Accessibility Survey

City of Downey Cherokee Drive - Downey Avenue To Lakewood Boulevard

Date of Inspection
2/2/2017

Disability Access Consultants

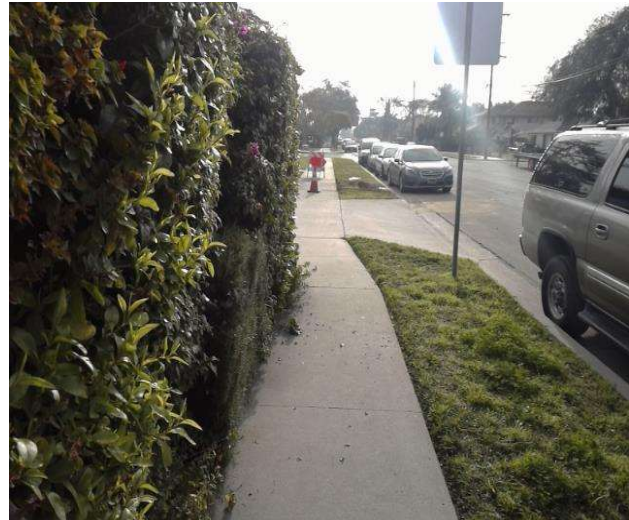
Sidewalk width at the obstruction is not compliant.

On-Site Finding 38.00 inches

Sidewalk width at the obstruction shall have the recommended value.

Change In Level West Of Brookshire Avenue @ 33.945922, -118.125154227018

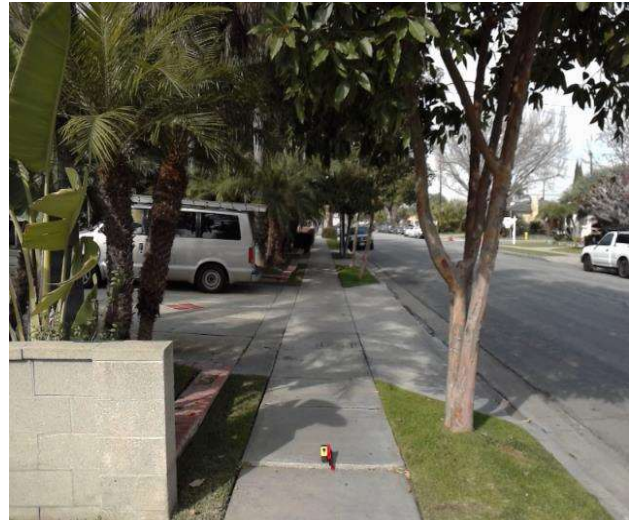
There is a change in elevation greater than recommended value.

On-Site Finding 1.25 inches

Ensure that the change in elevation is within the recommended value.

Change In Level West Of Dolan Avenue @ 33.947035788035, -118.127448856831

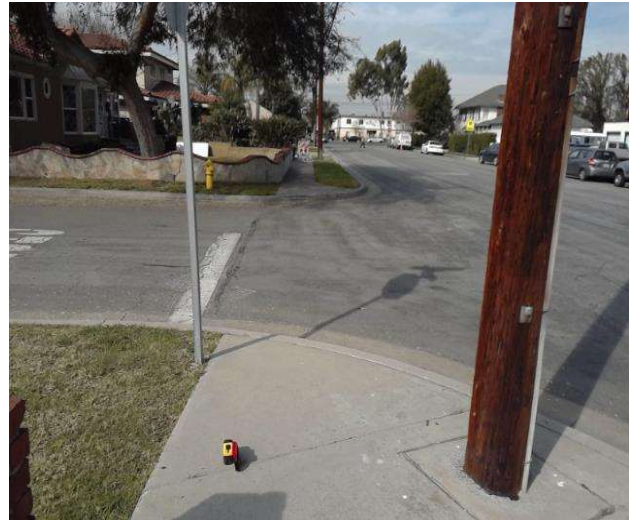
There is a change in elevation greater than recommended value.

On-Site Finding 0.62 inches

Ensure that the change in elevation is within the recommended value.

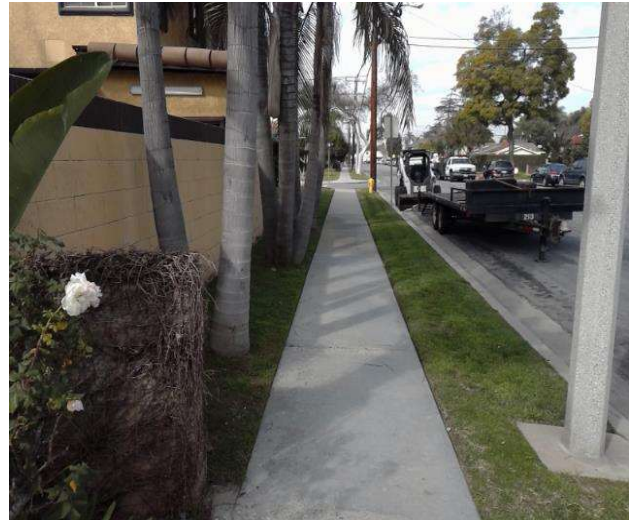
Sidewalk cross slope is not compliant.

On-Site Finding 3.20 percent for 20.00 feet

Repave the sidewalk surface with the recommended cross slope.

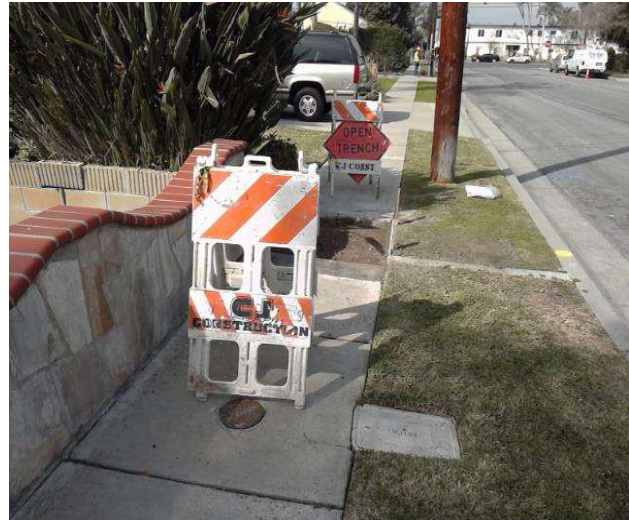
Section of sidewalk is missing and consists of dirt, grass or gravel.

On-Site Finding 5.00 feet

Provide a compliant sidewalk for the missing section.

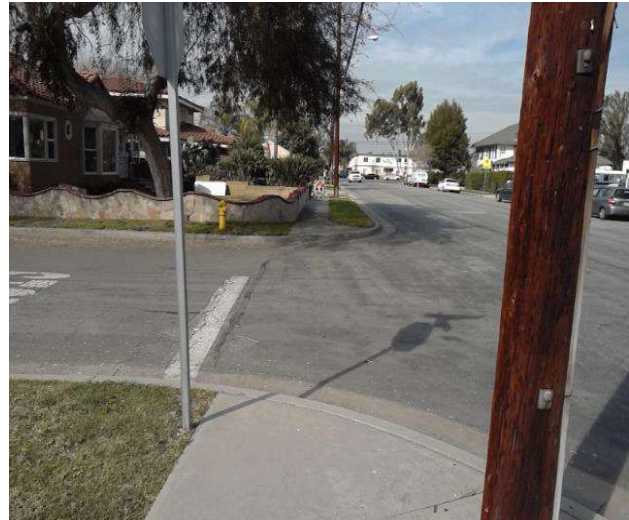
There is a curb on the designated path of travel.

On-Site Finding Not Compliant

Provide a compliant curb ramp.
